**NW Natural ISS Field Pilot Study Implementation
Gasco Sediments Site – September/October 2023
Field Change Request Form**

Project Name: Gasco Sediments Site **Contractor:** Sevenson Environmental Services, Inc.

Field Activity: ISS Field Pilot Implementation **Request Number:** 1

Field Change Request Title: Repositioned ISS Pilot Study Footprint and Post-Construction Sand Placement

Figure 3-2
Proposed ISS Field Pilot Study Location
 Final Revised in Situ Stabilization and Solidification Field Pilot Study Work Plan
 Gasco Sediments Project Area
GASCO0054083

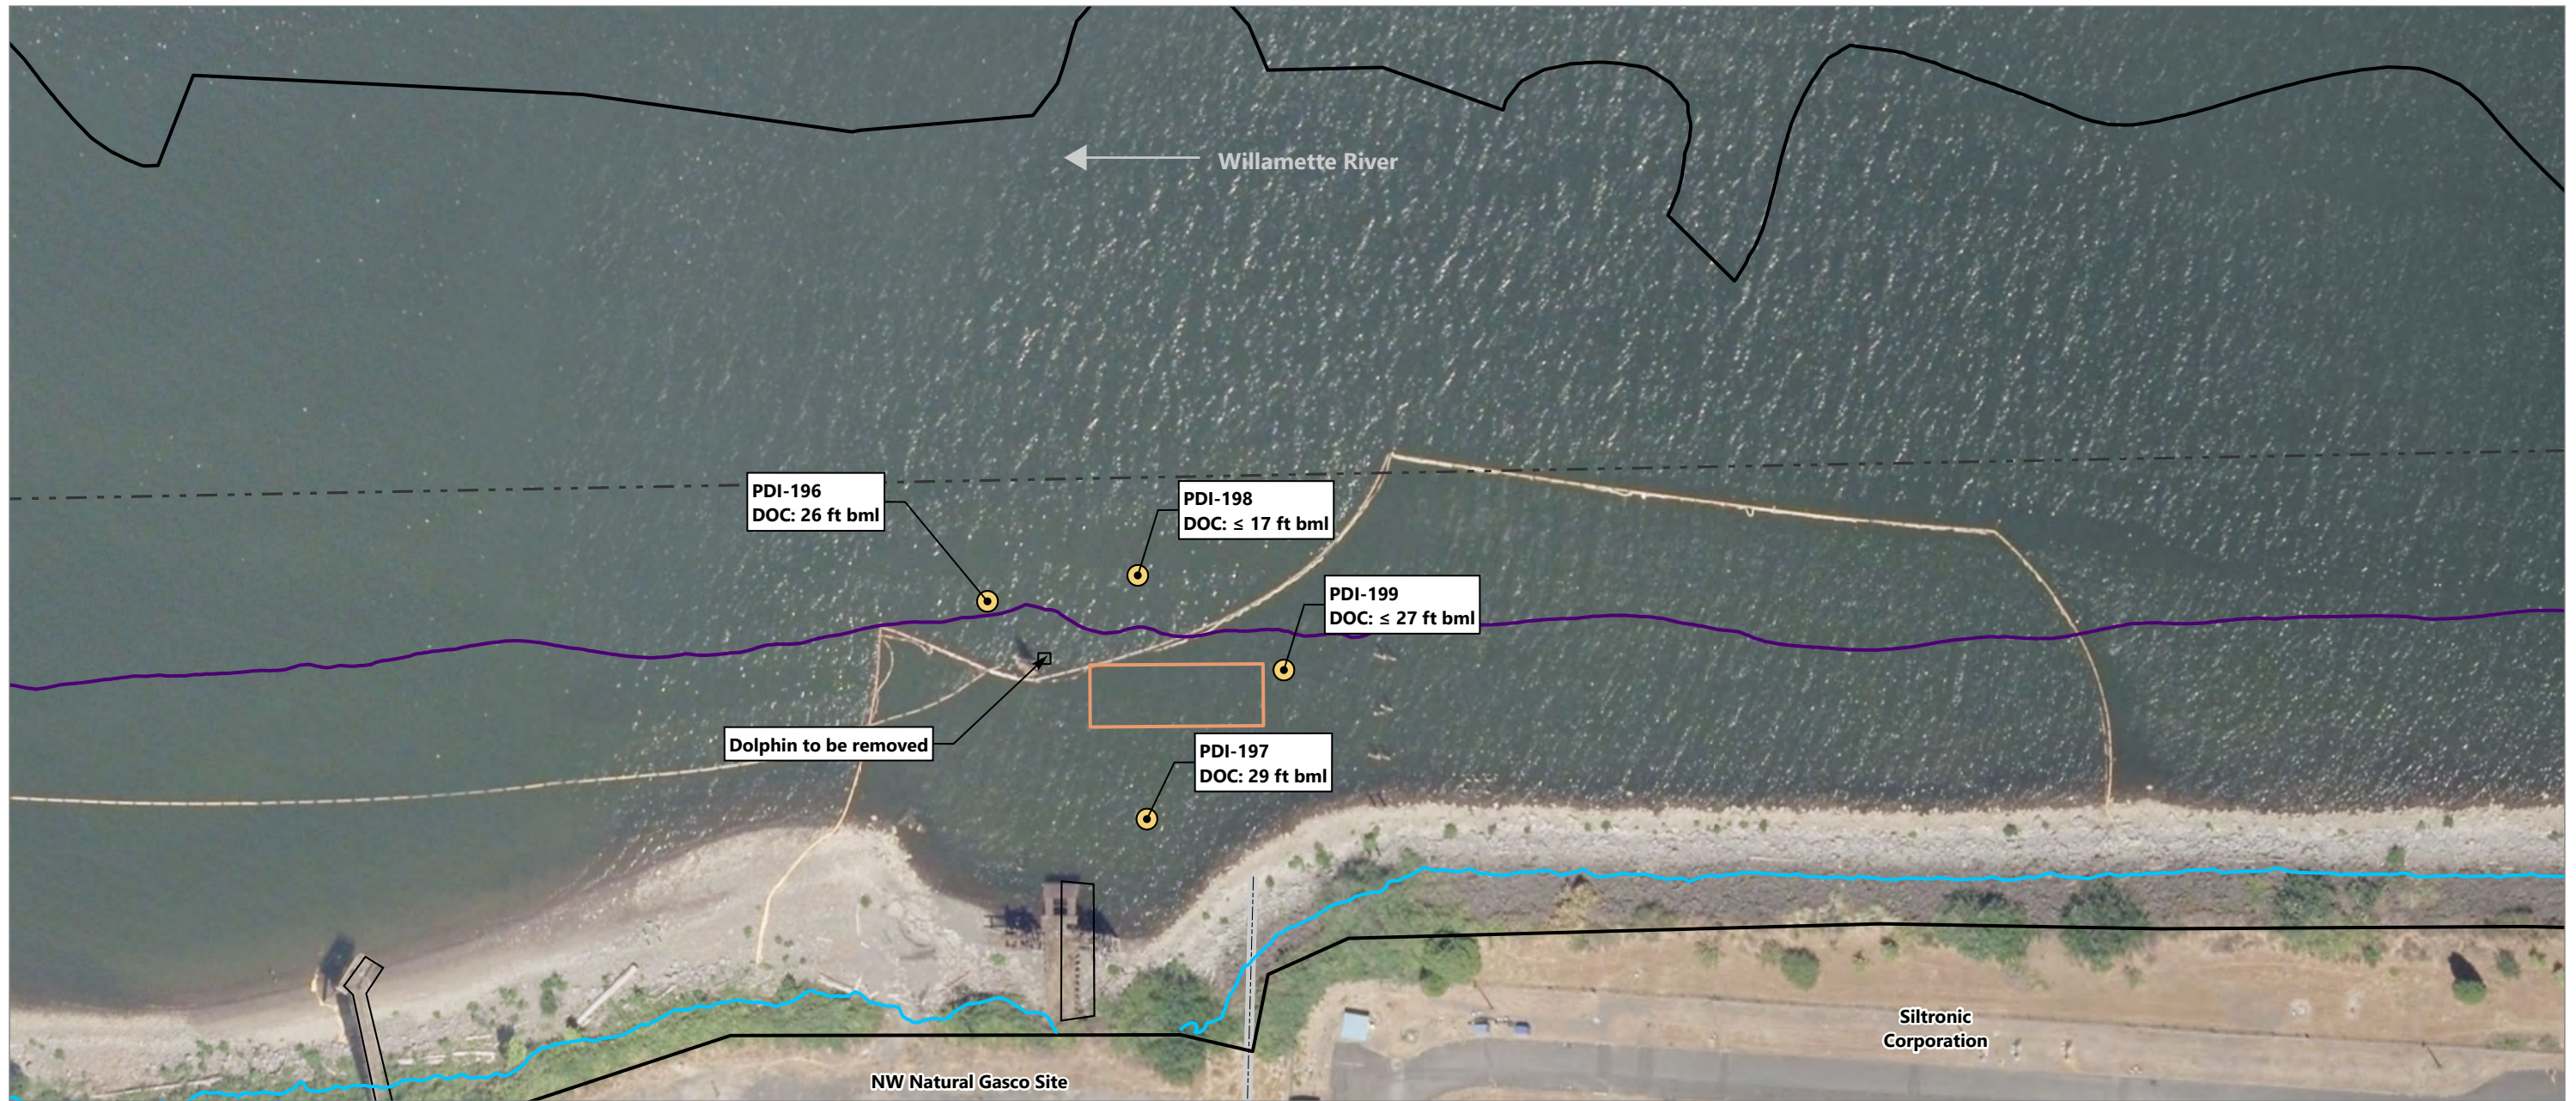
Based on the results of the multiple lines of evidence evaluation, the FPS footprint was proposed directly adjacent to the ISS bench scale treatability testing location ISSTS-003 and in close proximity to the Siltronic outfall, as shown in Work Plan Figure 3-2 (Attachment A). This proximity allows for the following: 1) direct comparison of the FPS strength and permeability results (see Work Plan Section 3.3.8.3) to the bench scale testing results for the *Additional Revised In Situ Stabilization and Solidification Bench Scale Treatability Study Work Plan*; and 2) demonstration that the work can be successfully performed without impacting adjacent structures.

- Remains directly adjacent to ISS bench scale treatability location ISSTS-003 (see Work Plan Figure 3-2 in Attachment A).
- Remains sufficiently offset from the navigation channel such that no work will occur in the 10-foot offset (Figure 2).
- Relocates the ISS footprint closer to subsurface sediment core location PDI-198 where the DOC is 17 feet below mudline (see attached Work Plan Figure 3-3 in Attachment A). To maintain the same level of conservatism identified in Section 3.1 of the Work Plan, NW Natural will maintain the originally proposed DOC of 30 feet below mudline in any expanded FPS area column location.
